Date: Nov 4, 1998

To: T10 Committee (SCSI)

From: George Penokie (IBM)

Subject: Persistent Reservations

Figure 1 - Device server interpretation of PREEMPT service action

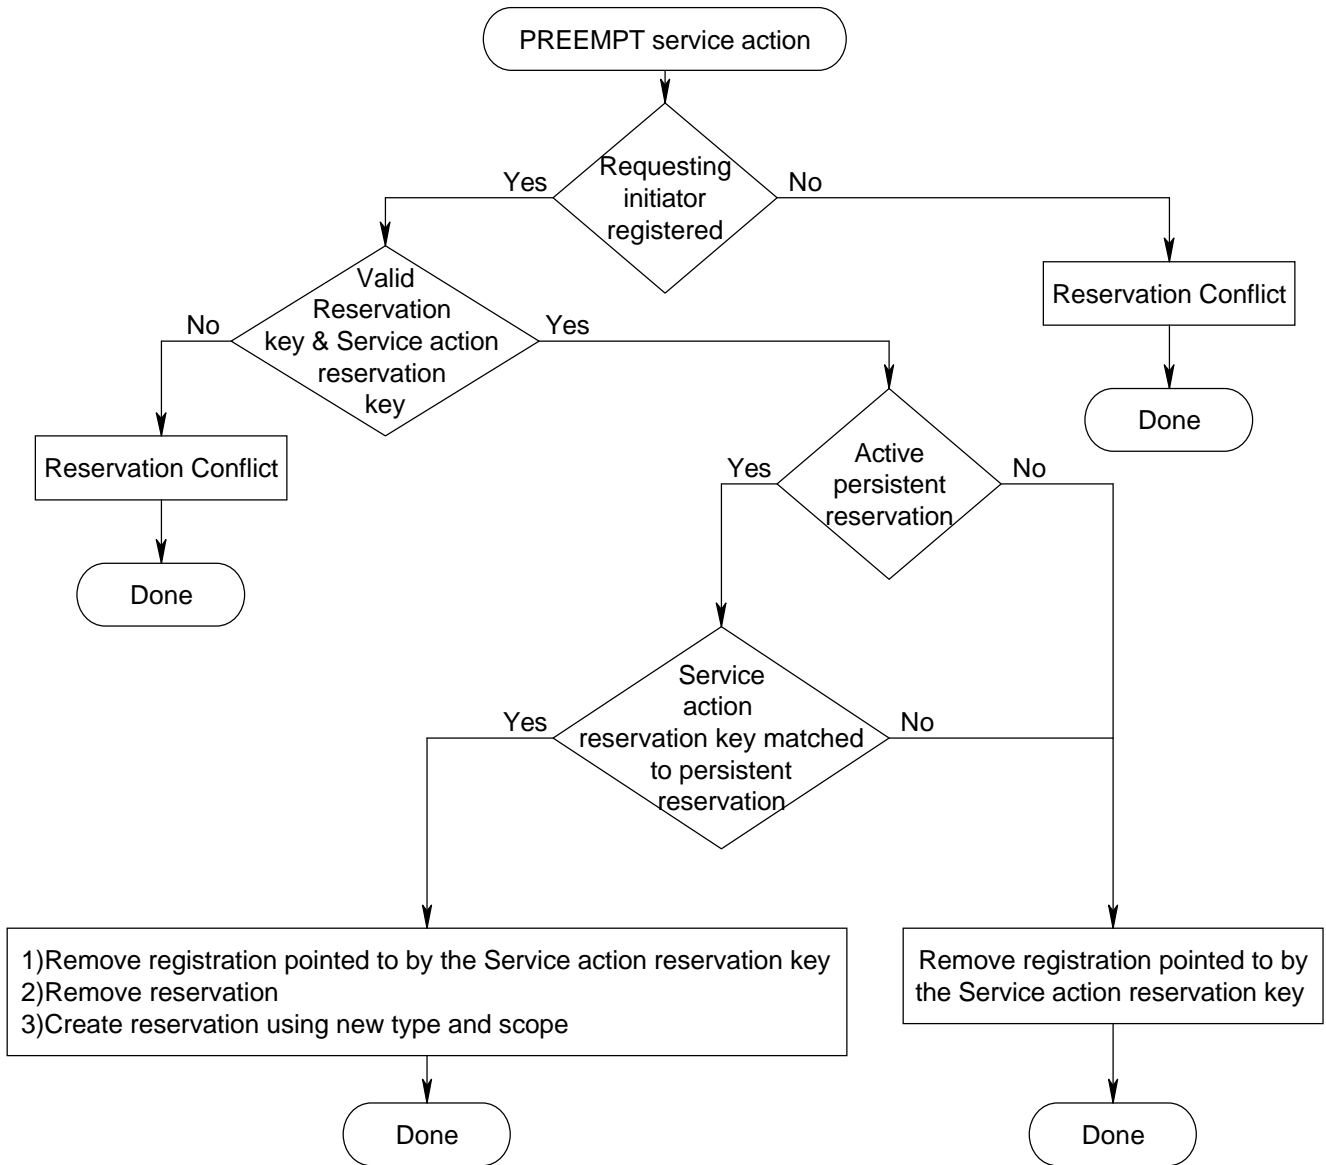
See figure 1 for a description of how a device server should interpret a PREEMPT service action to determine the actions it should take (e.g., preempt persistent reservation, preempt registration or preempt both registration and persistent reservation).
